**RE: Sealed Source Registration for MDS Nordion Haan, GammaMed 212**

Thank you for your email of September 7, 2001, in which you requested further clarifications.

Schéma N°  
 GM212.03-004

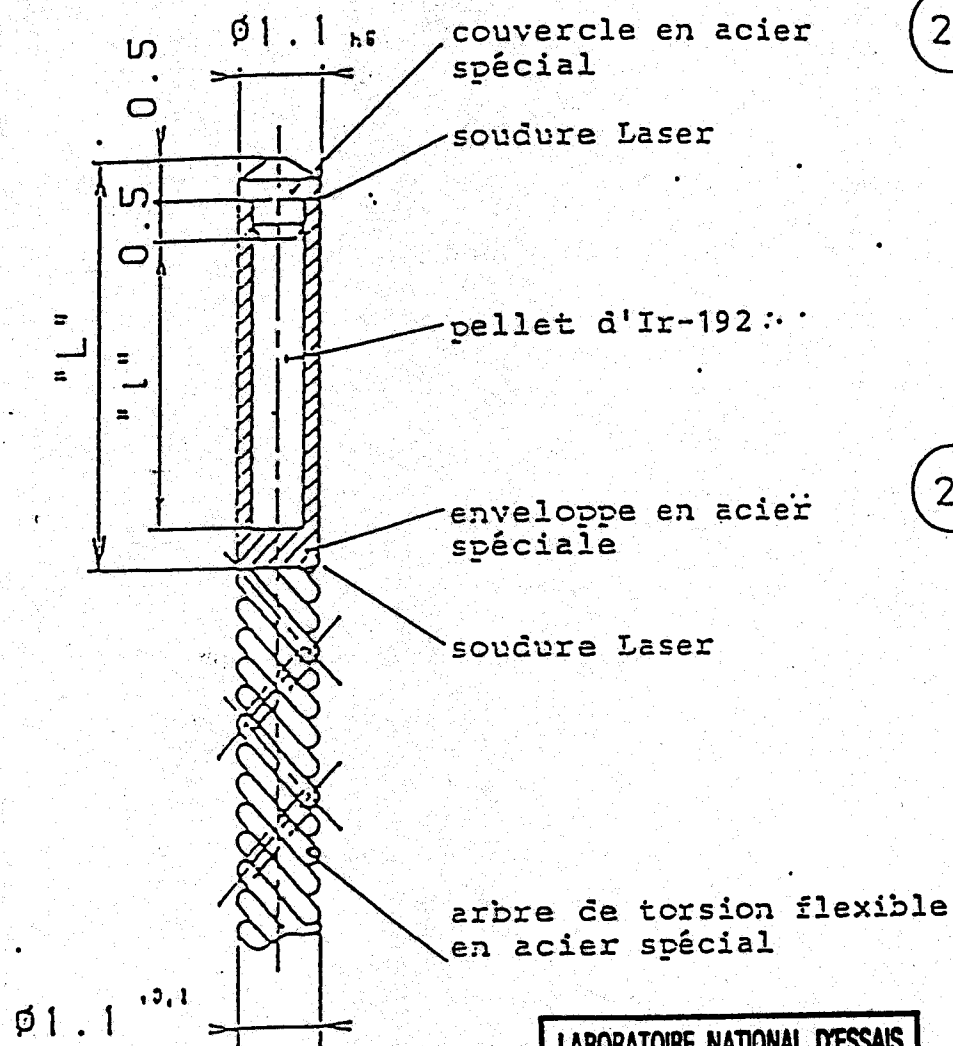
1. In section 7.1, BAM Testing, you stated that BAM tested models in configurations per drawings GM212.03-004, GM212.13-002 and GM212.13-001. However, reading the test results in Appendix G, it appears that both source assemblies tested were only of the configuration per drawing GM212.03-004. Drawings of the GM212.13 series are not mentioned in the BAM testing. Please confirm that BAM tested only models constructed per drawing GM212.03-004 or provide additional information showing the results of testing on other designs. Also, please describe any effect to the design due to raising the maximum source capacity from 10 Ci as stated on GM212.03-004 (tested version) to the 15 Ci stated on GM212.13-010 (application version).

The two source assemblies tested by BAM and described in the certificate D/0048/S were of the model GM212.03-004. The drawing GM212.03-004 is the general assembly drawing. The additional two drawings GM212.13-002 and GM212.13-001 are detail drawings of the source assembly and describe the source enclosure and source cover respectively. These drawings are listed as such in paragraph 5 titled, "Essential drawings," of the German Special Form certificate D/0048/S-85 (Rev.1).

The source capsule assembly will not be affected by an activity of 555 GBq. The source is manufactured from either ANSI Type 316L or DIN 8556 Type 1.4404 stainless steel. The similarly designed CIS-US, Inc. model 724 source assembly, is also manufactured from ANSI Type 316 or 316L stainless steel and has been approved for 740 GBq (20 Ci).
